**OFFICIAL COORDINATION REQUEST FOR
NON-ROUTINE OPERATIONS AND MAINTENANCE**

COORDINATION TITLE- 18 MCN 02 Spill pattern deviation

PROJECT- McNary

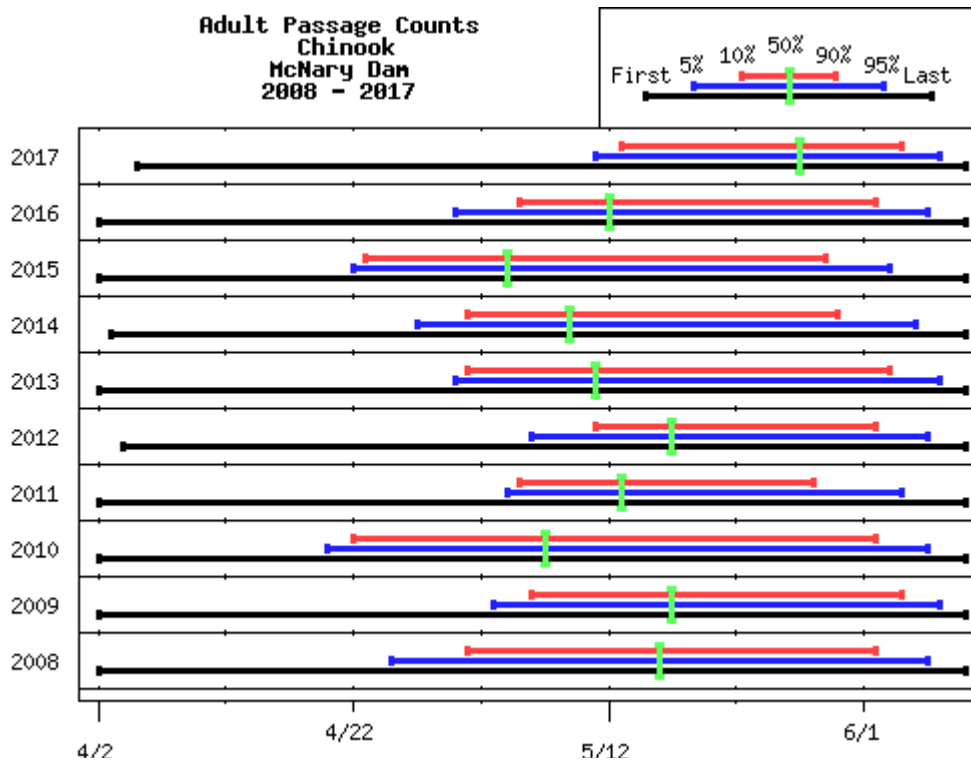
Type of outage required: Use revised spill pattern (attached) until spillbay 2 can be available for adjustment using a crane.

Impact on project operations: Spill pattern requires slight modification to allow for inability to adjust spillbay 2 until crane 6 is repaired. **Spillbay 2 will operate with 4 stops until crane 6 can return to service. See attached modified table.**
